STAFF RECOMMENDATION

1405 Dallas Avenue

August 15, 2018

Application: New Construction—Addition; Partial Demolition

Figure 4. An existing addition (constructed c. 2012) and an existing screen porch (constructed c. 2013) will be removed as part of the application.

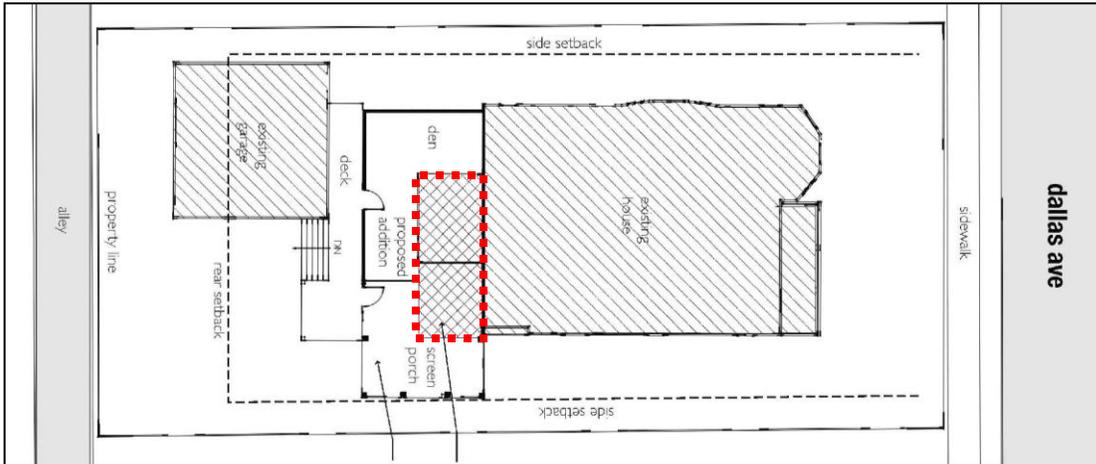
Partial Demolition: The applicant is proposing to remove existing additions approved in 2012 and 2013 (Figure 4). Staff finds that because these additions were recently

constructed, they do not contribute to the historic character of the house. Their demolition meets the design guidelines.

Figure 5. The new door opening proposed on the right elevation.

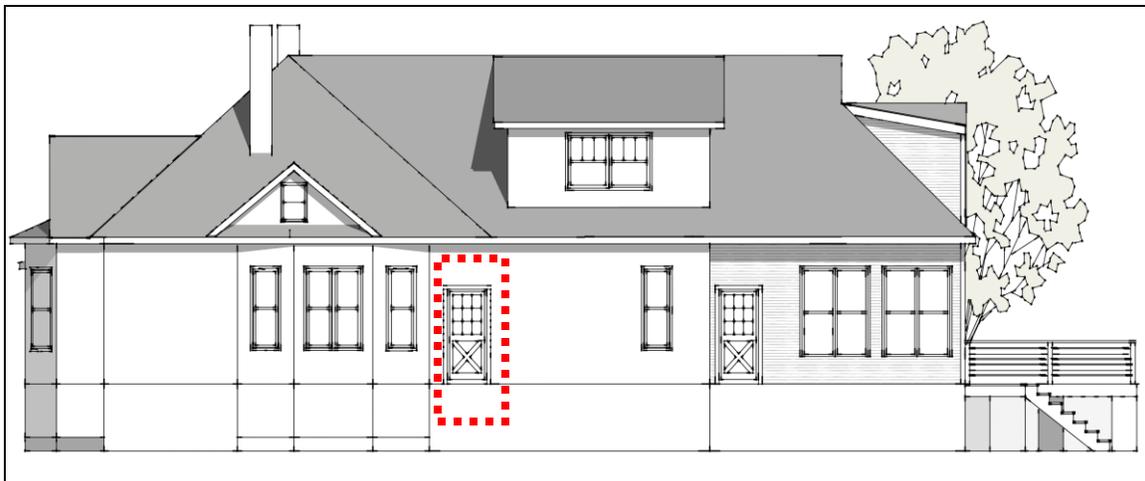
The applicant also plans to create a door opening on the right façade, behind the bay (Figure 5). The new door opening will be located in the back half of the house and will not be highly visible because it is behind the bay. Staff finds that the partial demolition of the wall for the new door opening is therefore appropriate.

site plan
scale: 1/16" = 1'

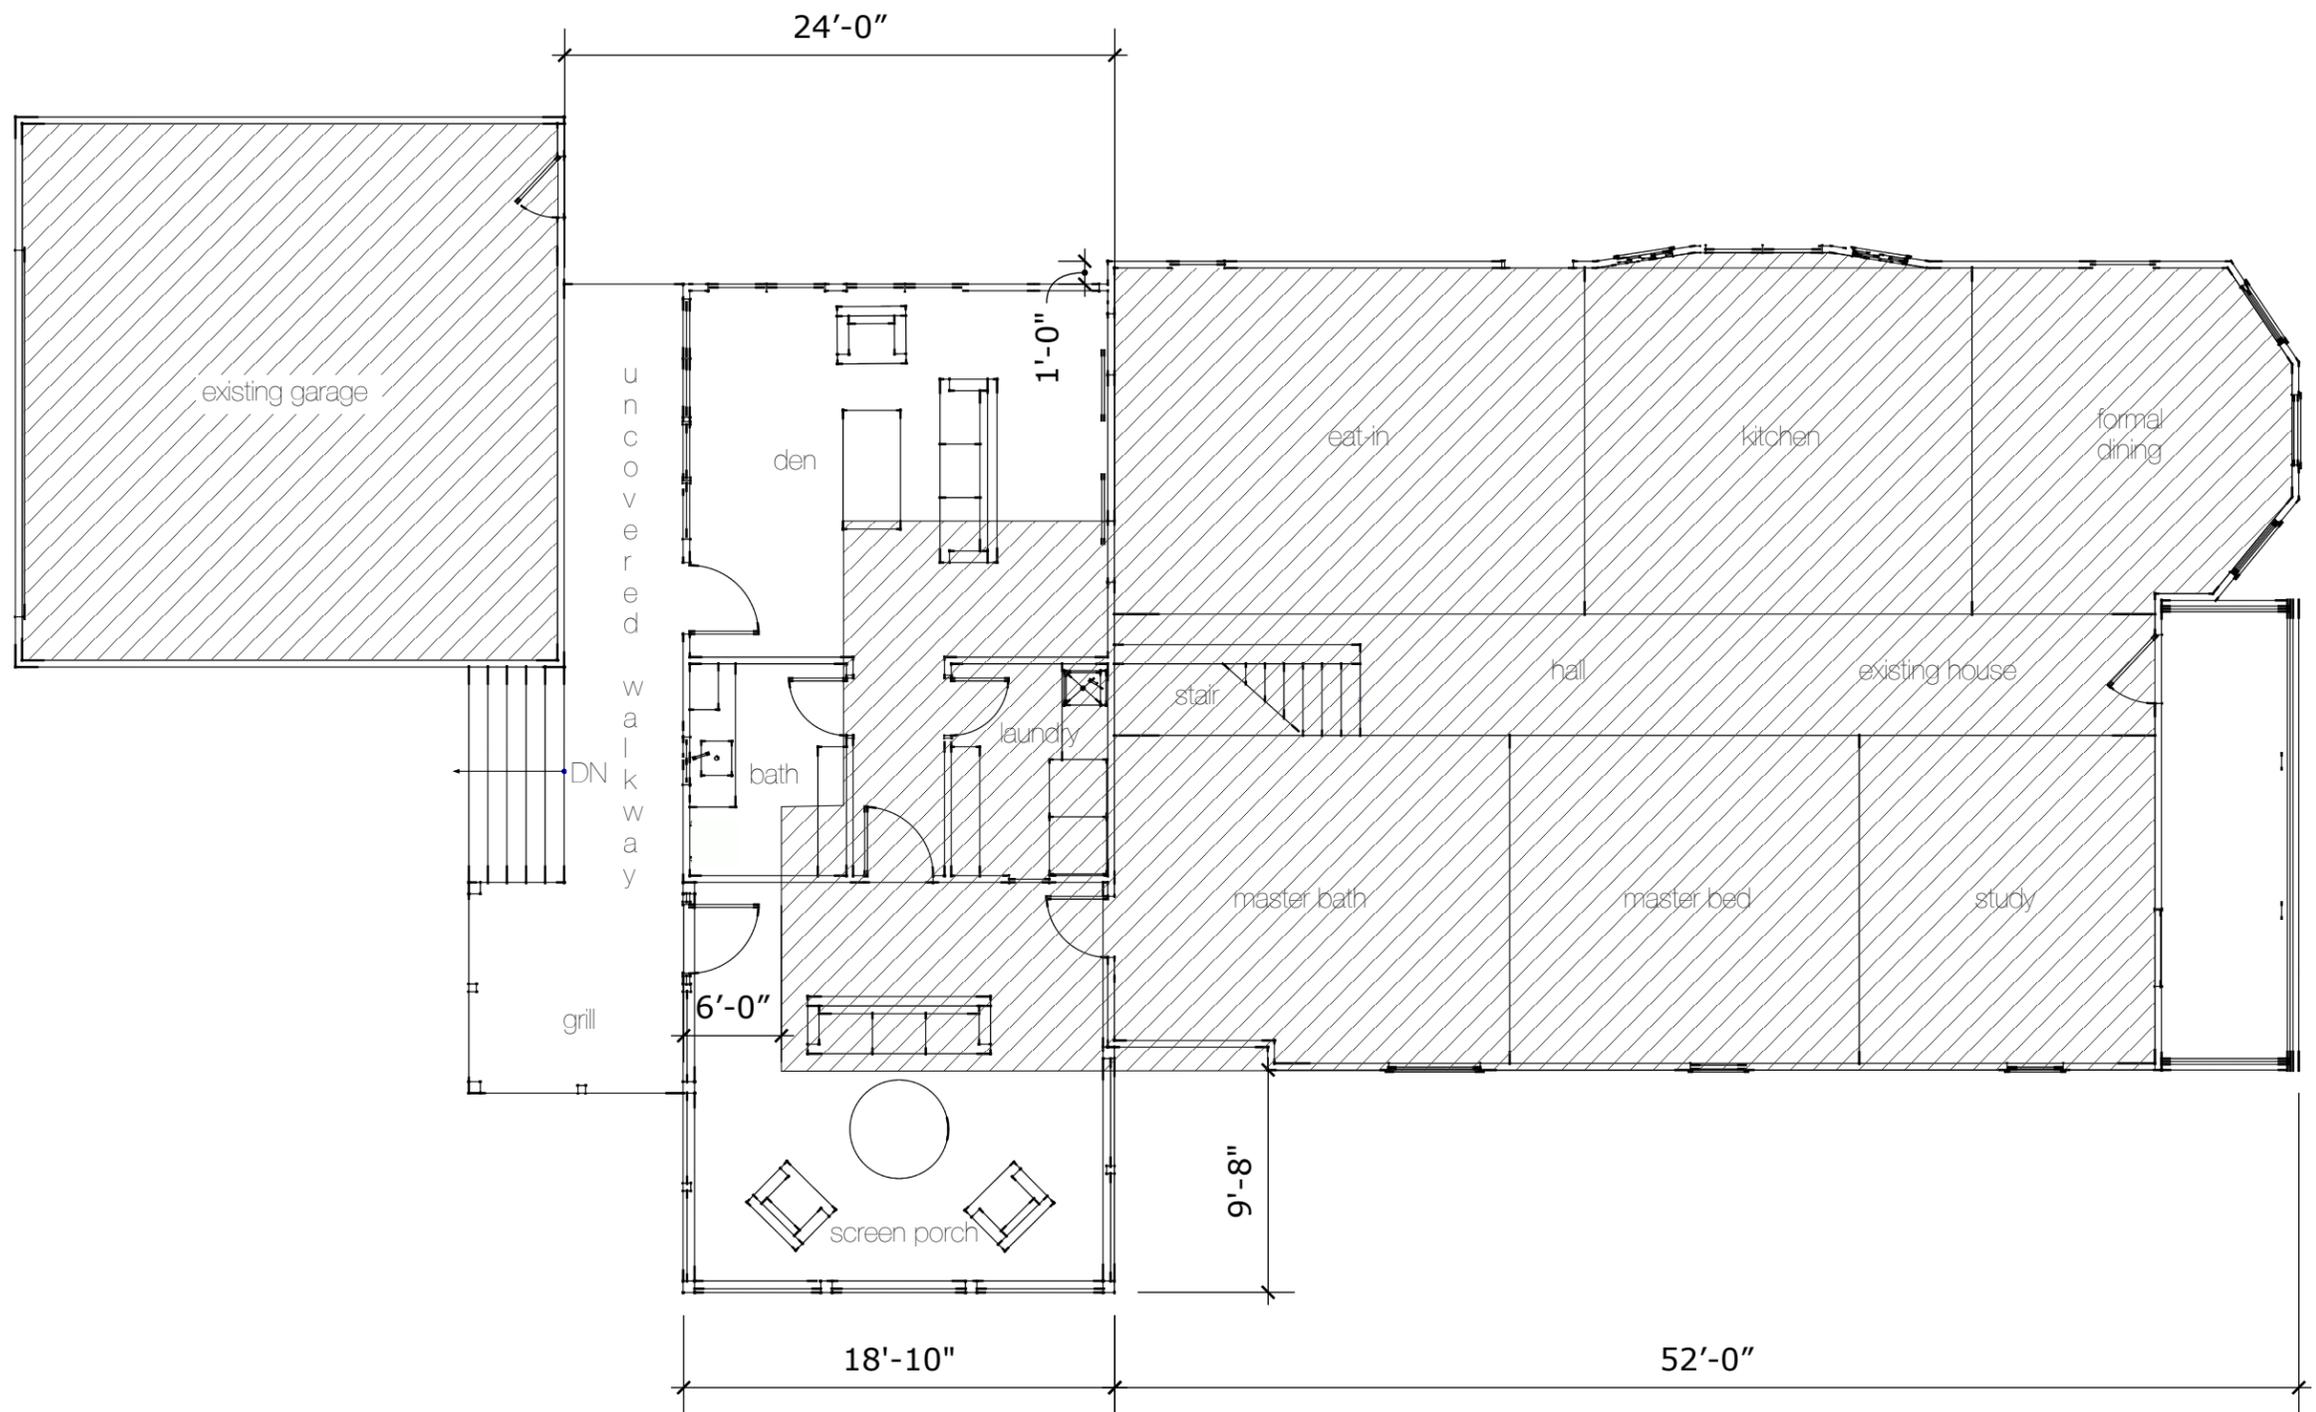
The addition will be located just five feet (5') from an existing garage, approved by MHZC in 2012. The design guidelines typically require a minimum distance of twenty feet (20') between the back of the house and an outbuilding. MHZC has reduced the distance to as little as ten feet (10') in the past when there are unusual lot conditions. It is rare for MHZC to approve less than 10' of separation, but the conditions of this lot make it a good case for an exception. The lot is unusually shallow at just one-hundred and thirty feet (130') deep, and the garage is existing and cannot be easily relocated closer to the alley. In addition, the proposed addition is not overly large; it is increasing the depth of the house by just seven feet (7'). Staff therefore finds the proposed distance between the outbuilding and the new addition to be acceptable, in this instance.

Setback & Rhythm of Spacing: The proposed addition meets all base zoning setbacks. It is thirteen feet (13') from the right side property line and five feet (5') from the left side property line. It will be approximately forty-one feet (41') from the rear property line. The addition, which does extend wider than the historic house at the rear, will not affect the rhythm of spacing of houses along Dallas Avenue. Staff finds that the addition's
